Project	IEEE 802.16 Broadband Wireless Access Working Group < http://ieee802.org/16 >	
Title	Solutions for some AIs in last meeting.	
Date Submitted	2007-03-04	
Source(s)	Wu Xuyong, Huawei	Voice: +86-755-28973547 Fax: wuxuyong@huawei.com ,
Re:	IEEE 802.16-07/010: IEEE 802.16 Working Group Letter Ballot Recirc #24a: Announcement (2007-02-01)	
Abstract	Following AIs assigned in last meeting.	
Purpose	To consolidate the 16h draft.	
Notice	This document has been prepared to assist IEEE 802.16. It is offered as a basis for discussion and is not binding on the contributing individual(s) or organization(s). The material in this document is subject to change in form and content after further study. The contributor(s) reserve(s) the right to add, amend or withdraw material contained herein.	
Release	The contributor grants a free, irrevocable license to the IEEE to incorporate material contained in this contribution, and any modifications thereof, in the creation of an IEEE Standards publication; to copyright in the IEEE's name any IEEE Standards publication even though it may include portions of this contribution; and at the IEEE's sole discretion to permit others to reproduce in whole or i

531a) change figure h46 as follows(only to move the shared part to the front of the 4 frame.):

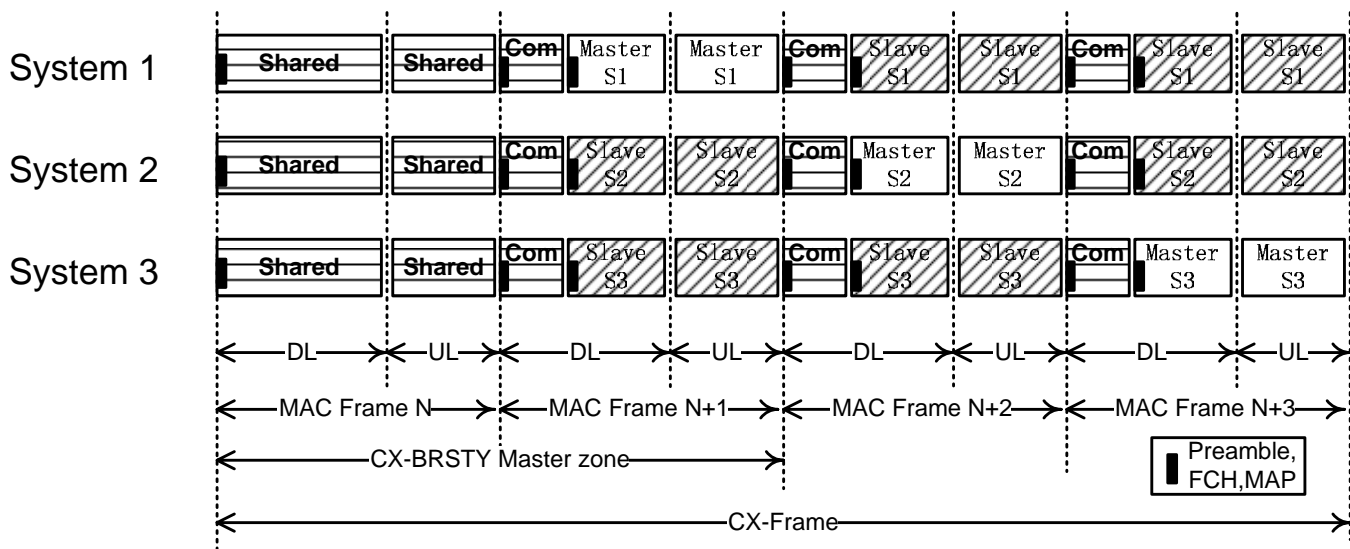
Comment: [531] By Phillip Barber

What if a BS is a part of more than one neighborhood or community? part of three neighborhoods? four? nine? How can the available solution methodologies cope with the complexity of such decision making?

Discussion: There is some discussion within Mariana's AIs, and some reply is relating to this topic, by the proposal of following frame structure, we limited only up to 3 systems within the neighborhood to share the radio resource in one channel.

Resolution: We have limit the number of subframes to three in one working channel to allow the coexistence within neighborhood.

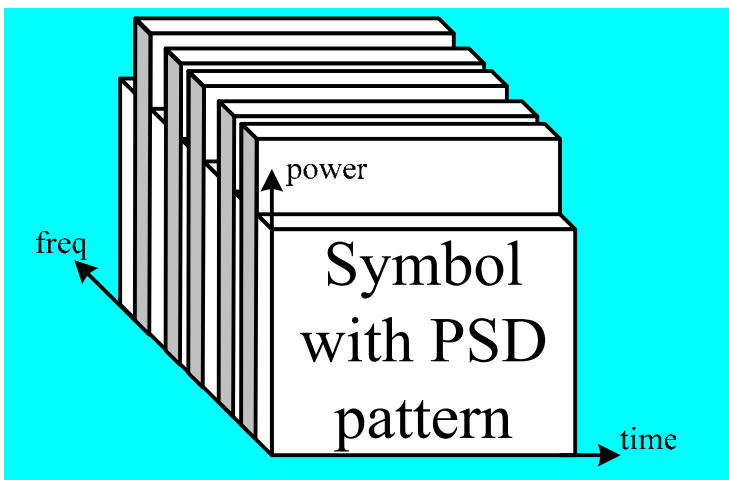
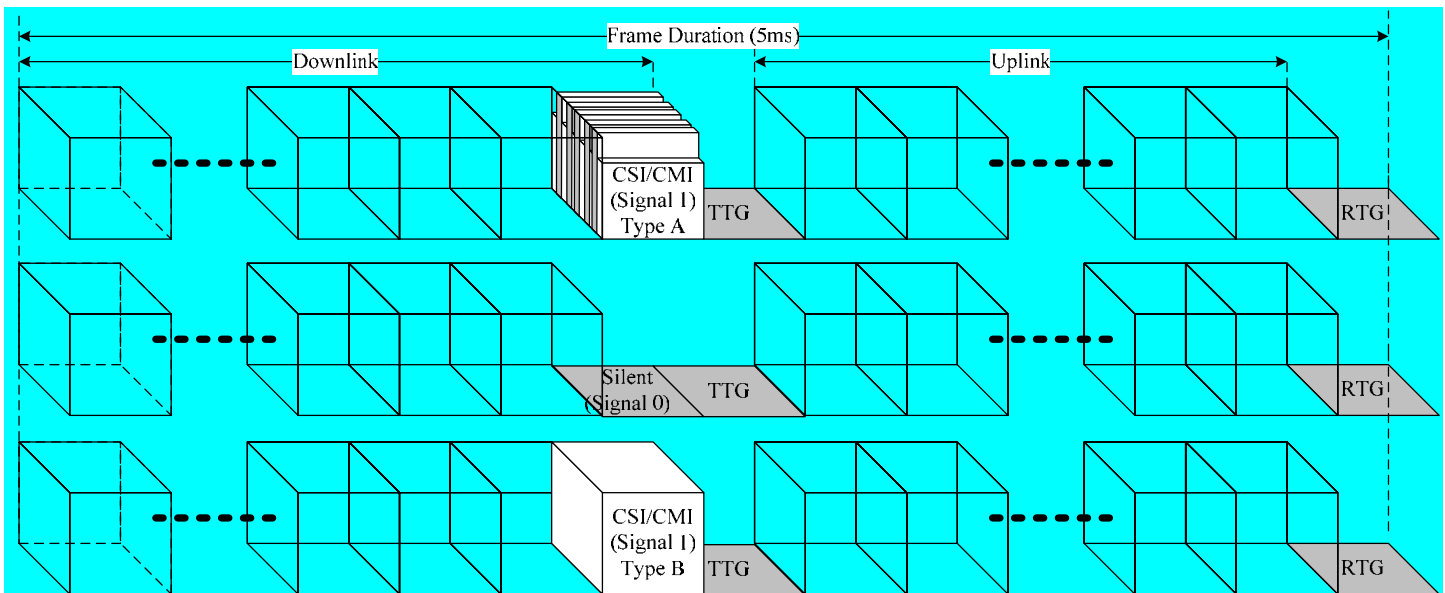
Comment: [368] By Mariana GoldHamer

The Energy keying in the frequency domain is using now the CX CC, but the text in clause 15.3.1.2.2 is not reflecting this.

The transmission is done in consecutive coexistence time slots, spaced apart by T_{iptx} seconds. The first CSI in the series starts with CSI start signal, while the CSI in the series contains the Tx_end signal, the continuation in sequential CSI slots starts with the CSI_Continuation, as defined Table h 9. The IP identifier of the BS and an 8bit CRC, are transmitted between these signals, the L.S.B (least significant bit) for each field being transmitted first. The transmission of the above information uses only the preambles for the sub-channels 6,8,10,12,14,18,20,22,24,26 (10bits / symbol), the L.S.B. corresponding to the lowest sub-channel index.

Change the text between lines 44-54 to read:

The transmission is done in consecutive slots of the CC CX, named Freq_Key 1, Freq_Key 2, Freq_Key 3 and Freq_Key 4. The used slots in the above series start with CSI start signal and end with the CSI_Continuation, as defined Table h 9. The last used slot ends with Tx_end signal, defined as well in Table h9.

The message transmitted inside the above frames is BS_NURBC (see 15.5.6.2.1)

The transmission of the above information uses only the preambles for the sub-channels 6,8,10,12,14,18,20,22,24,26 (10bits / symbol), the M.S.B. corresponding to the lowest sub-channel index.

Reply By Wu Xuyong:

- 1) CSI is not within CXCC currently,
- 2) BS_BURBC is CSI use only. BSD is used in CMI for the same purpose in another way.
